ADDENDUM NO. 1
to
PLANS and SPECIFICATIONS
for

Medina River Sewer Outfall, Segment 4
SAWS Job No. 12-2504

Issue Date: November 14, 2011

JOB NO. 6866-00
 DATE FEBRUARY 2010
 DESIGNER RRD
 DRAWN BMO
 CHECKED JUC
 DRAWING No. C-74
 SHEET No. 15

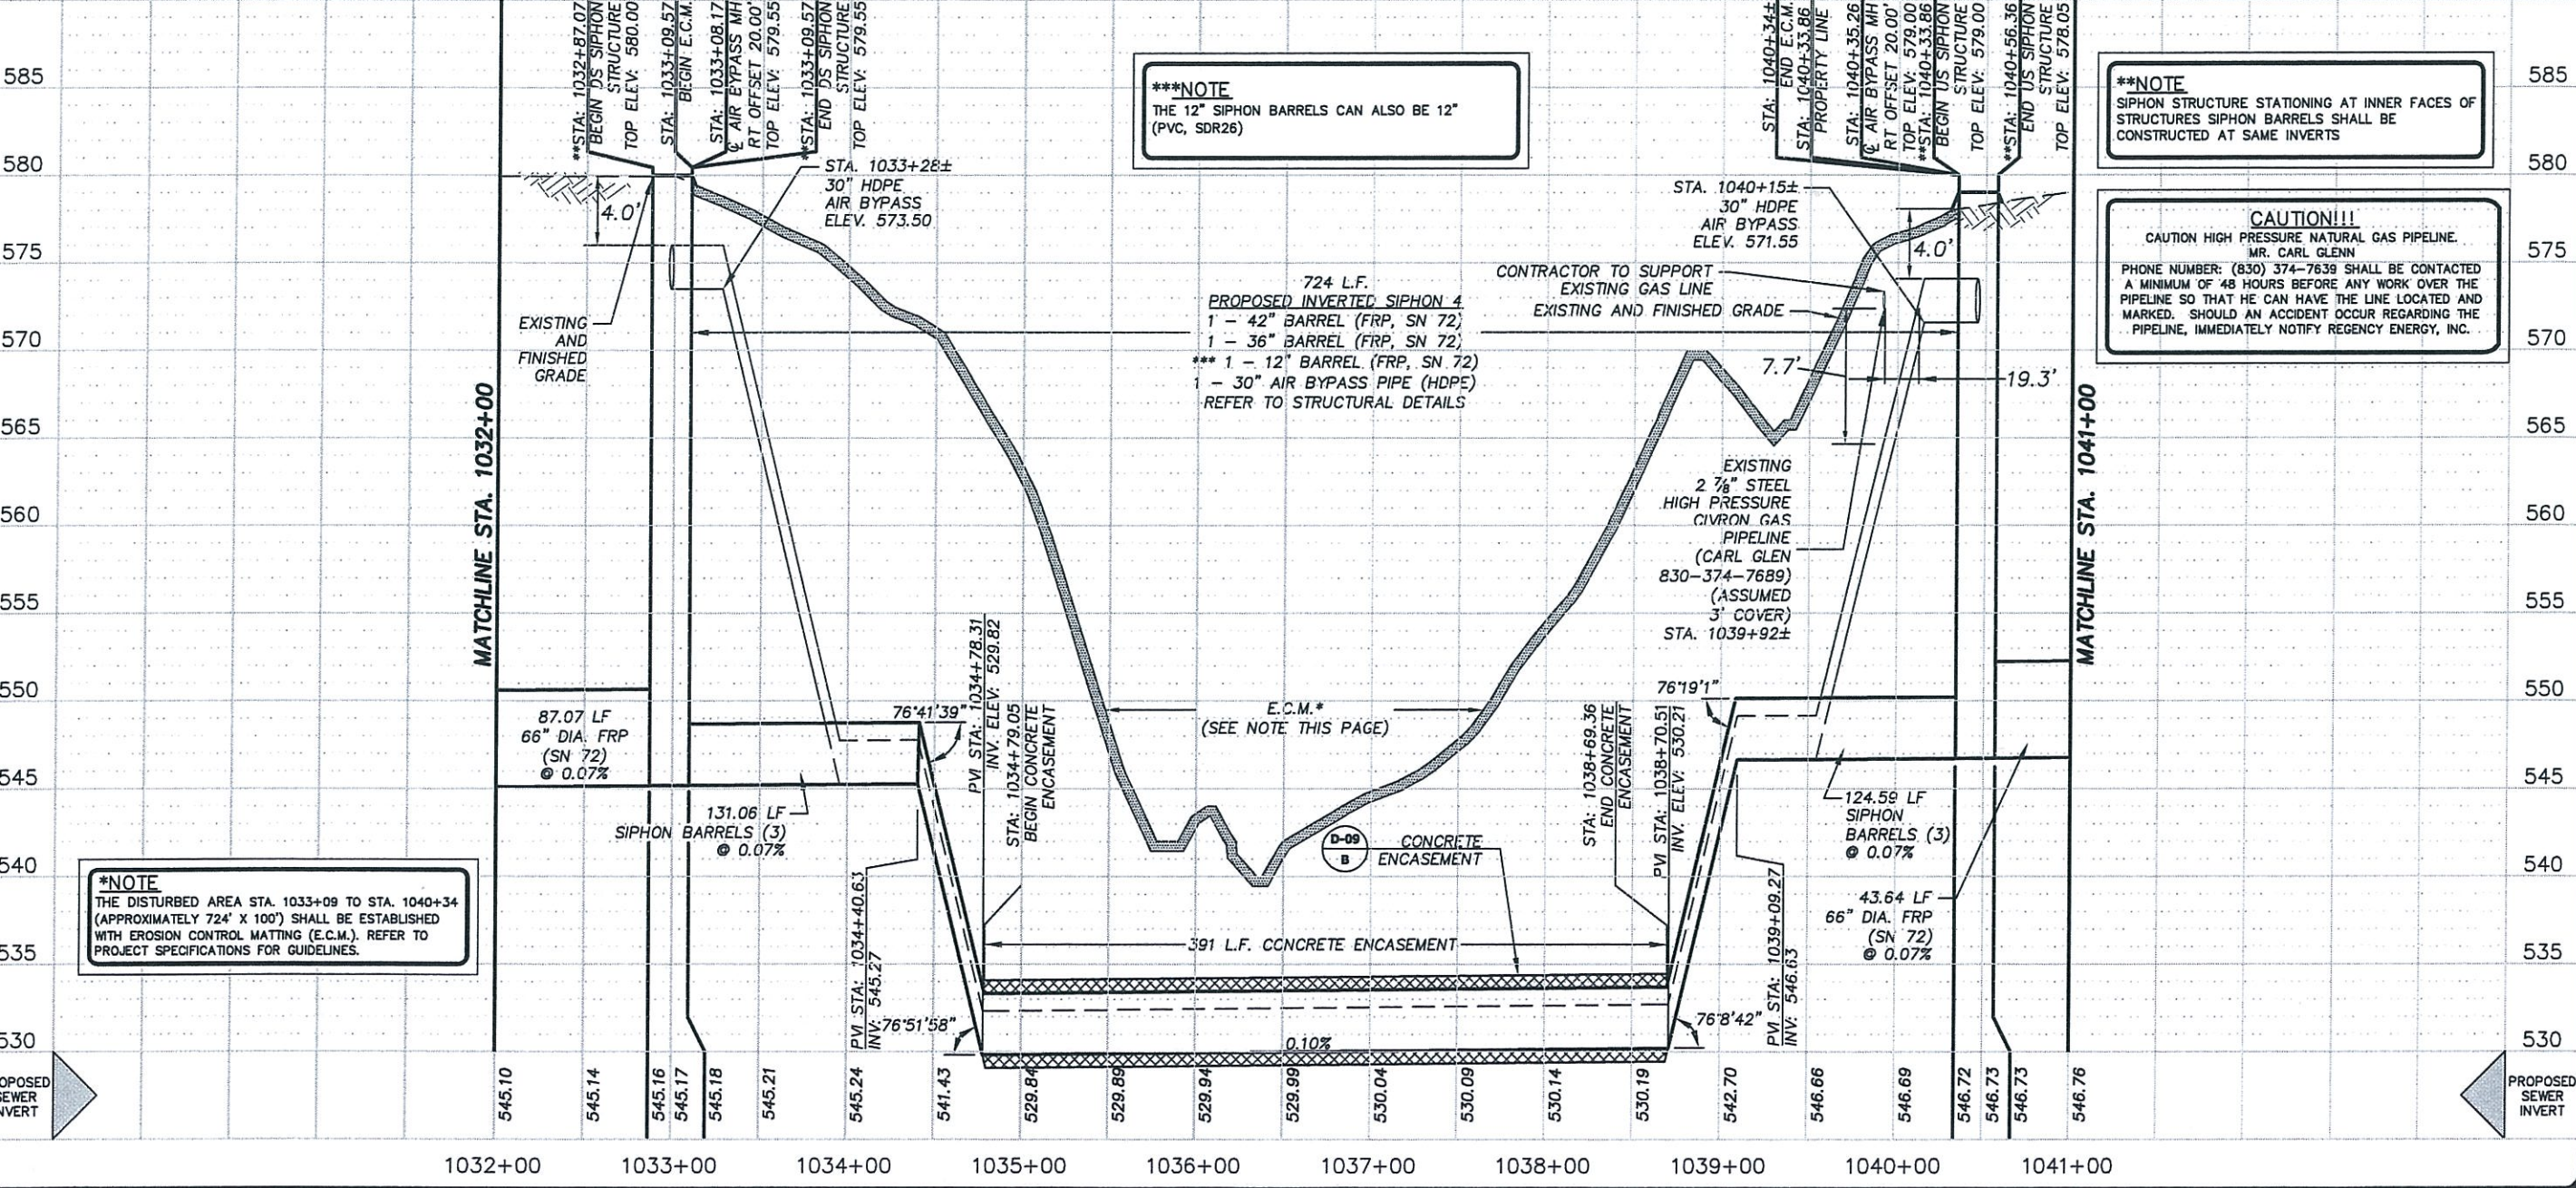
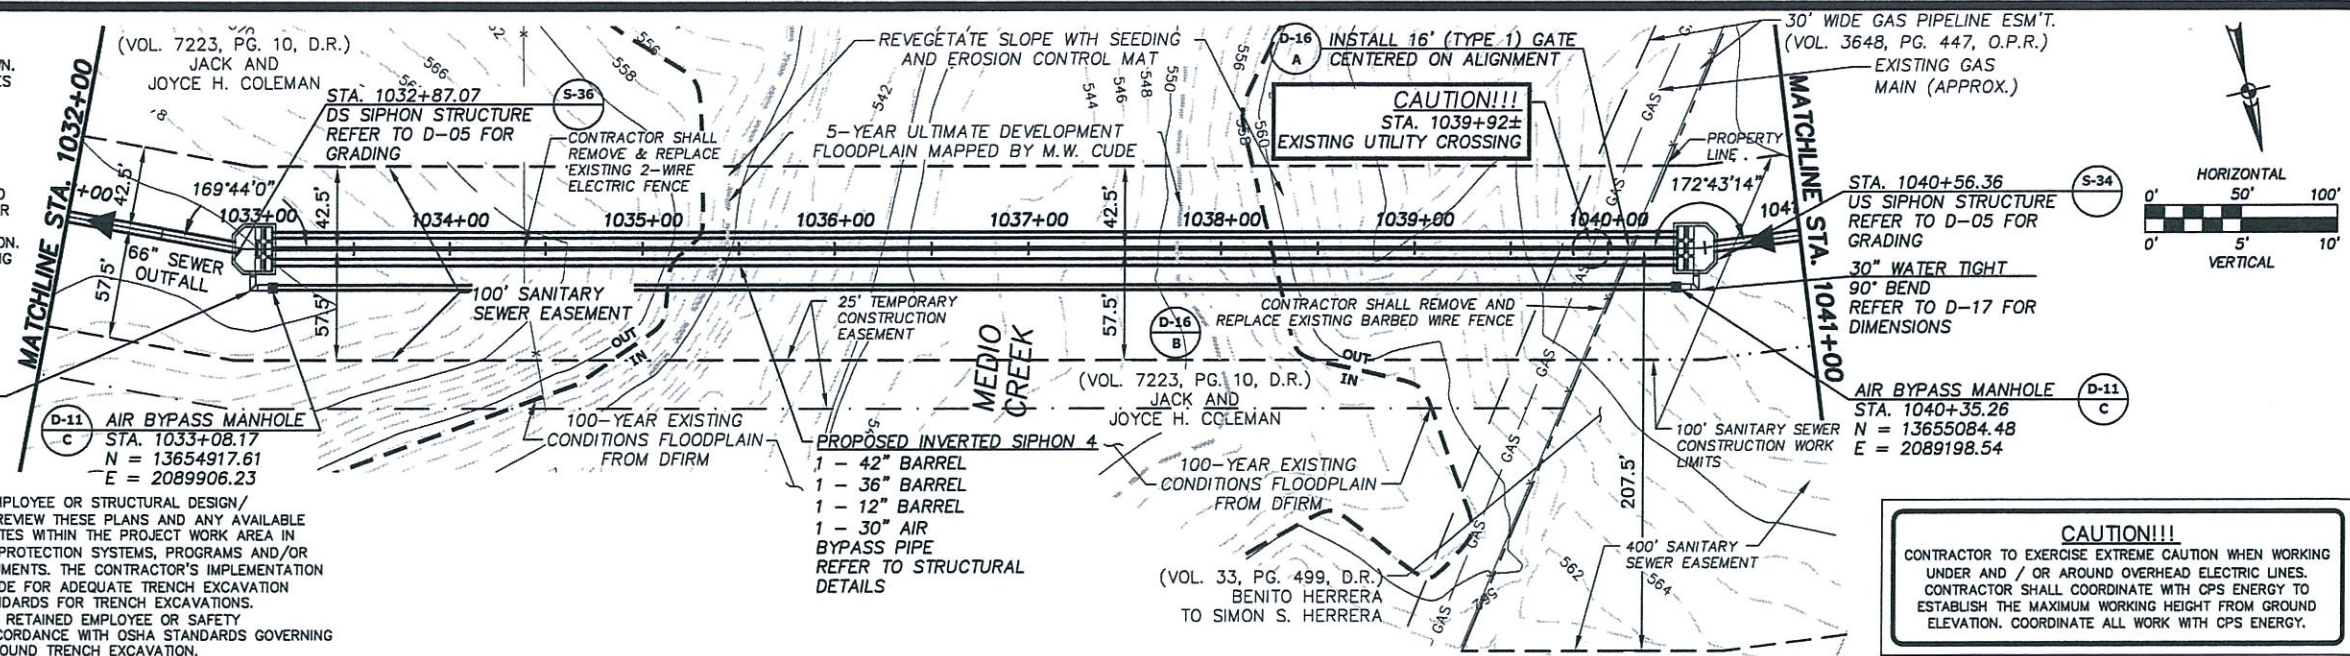
A. Drawing No. C-74, Sheet No. 15 – A 100' Sanitary Sewer Construction Work Limits has been added to plans. Remove and Replace this sheet with the attached plan sheet.
